Project #22-010
Hoggan Subdivision
Located at 1800 South 1600 West

Project Name: Hoggan Subdivision
Proponent/Owner: Bradley Hoggan / Bradley and Cathy Hoggan
Project Address: Approximately 1800 South 1600 West
Request: Subdivision
Current Zoning: NR-6
Date of Hearing: Feb. 10th 2022
Type of Action: Quasi-Judicial
Submitted By: Russ Holley, Senior Planner

RECOMMENDATION

Figure 2 shows the proposed subdivision layout

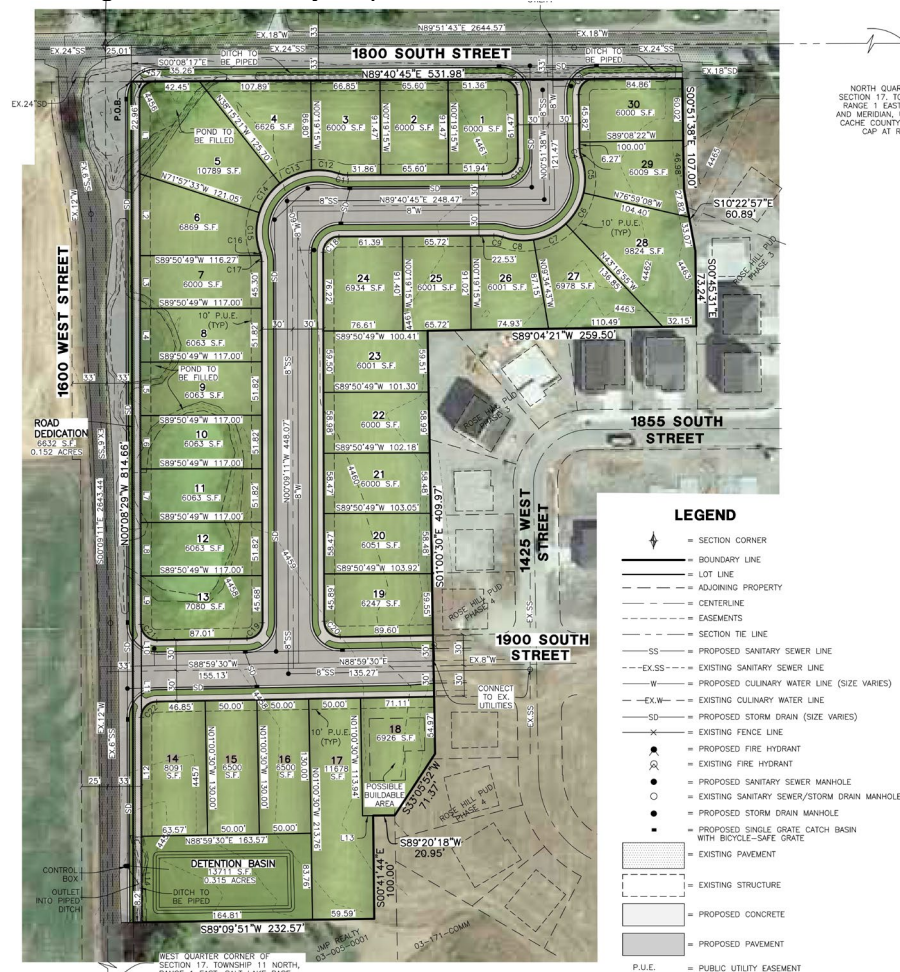
The LDC 17.30.190 requires projects serving twenty (20) or more dwelling units have at least three (3) street connections or stubs for future connections unless adjustments are warranted as per LDC 17.30.170.D. The LDC street connectivity requirement ensures equitable traffic distribution, efficient utility/infrastructure networks, better walkability and the continuation of Logan City's historic grid patterns. This proposal includes the creation of a new north-south street connecting to 1800 South and a new east-west street connecting to 1600 West and 1900 South (stub). A total of three (3) street connections are made with this proposal as submitted meeting the connectivity requirements in the LDC.

The Logan City Engineering Standards and Specifications contain the adopted street cross-section designs for all areas and all types of development within the city. For standard neighborhood residential developments, a “Local Residential Street” with a 60-foot cross section containing vehicle travel lanes, on-street parking, landscaping (park strip) and sidewalks are required. The proposed 30-lot subdivision shows a 60-foot cross section throughout the entire project site.

The LDC 17.30.100 regulates fencing and walls in residential developments. When subdivisions are adjacent to collector or arterial streets, developers with often choose to align lots with rear yards abutting the larger perimeter streets. For this submittal, lots 1-13 abut 1800 South and 1600 South with rear yards. In these configurations, a rear yard fence that is 4 feet tall or less may be placed on the property line, but a 6-foot-tall fence must be setback 10 feet from the rear property line. For consistency, the developer may require uniform fencing materials and landscaping designs in the rear 10 feet of these lots if 6-foot-tall fencing is desired. Corner lots are treated differently and allow 6-foot-tall fencing without setbacks in areas of the corner yard behind the home’s front façade.

The proposed subdivision complies with the LDC standards and limitations as proposed. Unless delineated as jurisdictional wetlands, the existing ponds on-site can be filled as long as all downstream irrigation users continue to receive their water shares. Fencing options should be

discussed for better overall subdivision design and landscape maintenance. The storm water pond on the south side of the project will require common area landscaping and maintenance. If 6-foot fencing is desired, the rear yard setback areas along 1600 West and 1800 South could be included in that common area maintenance plan for better consistency and appearance.

3. The stormwater common area near the south side of the project shall be listed as non-buildable on the final plat.
4. Three street connections shall be made for this project.

5. Street design shall conform to 60-foot right of way or Local Residential Streets.
6. Building setbacks, lot coverages, parking and driveway specifications shall be reviewed and approved on an individual basis and comply with the NR-6 requirements.

Preliminary Plan

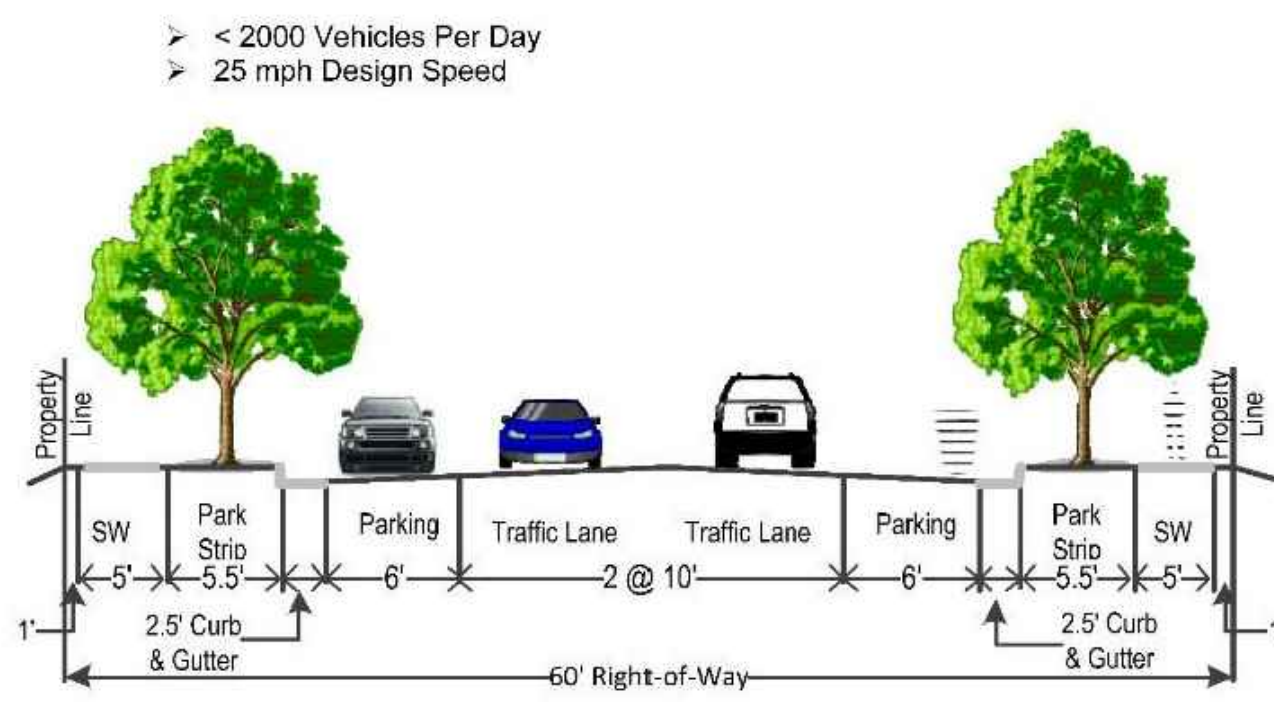
- Provide storm water detention/retention per Logan City Standards for this development. This includes the onsite retention of the 90% storm utilizing Low Impact Design methods

- Coordinate with Community Development and Fire Marshall to ensure that the number of accesses to the site comply with City standards. Modify current site plan as required.

- No civil plans for utilities were provided with this submittal, Public Works will review and approve these plans as part of the Building Permit review process.

- Construct curb/gutter, park strip, sidewalk and a radius corner per City plans and design standards on 1600 West and 1800 South. This will require that the existing ponds be filled in, relocated, etc by the developer with all necessary approvals from the Army Corps of Engineers. This construction shall be within the current road right of way dedicated portions for right of way.

- Developer shall provide a geotechnical report that shows the historical high ground water level, historical high-water table, and a California Bearing Ration for the final subgrade depth for the proposed pavement section in 1600 West and 1800 South. These roads shall be constructed to meet the Gridded road section per the City's current road design standards.

- Dedicate any right of way necessary to ensure a 66' right of way on 1600 West and 1800 South
- Maintain existing irrigation ditch and piping along south side of 1800 South, this may also include head gates as necessary for flow diversion. Coordinate requirements with the Spring Creek Cache Irrigation Company for irrigation needs and requirements.

- Provide storm drain piping and ground water piping as required for connections to historical drainage route associated with the existing ponds
- Existing road section for 1600 West is a former gravel road with a chip seal for the current pavement surface. Developer shall construct a full road pavement section for 1600 West to the center line of the right of way.

- Dedicated a 10' minimum public utility easement on all property lines and road frontages. The 10' easement can be reduced to 5' on interior property lines if the adjacent property has a public utility easement already recorded.

- This development is not being considered for a subdivision; therefore, dedication plat for road dedications and public utility easements, must be submitted to the City for review and approval prior to being recorded at the County Recorder's office
- CC&R's addressing maintenance of the Storm Water ponds, swales, and other infrastructure outside of a dedicated street.
- This plat does not show location of storm water detention/retention ponds or other LID areas. If intent is to place them on individual lots those storm water systems shall be associated with an easement and the responsibility to maintain the storm water systems assigned to an HOA. Alternatively, storm water detention/retention ponds can be located on common property and maintained by the HOA

- Place fire hydrants within 600 feet of all buildable areas of the lots.
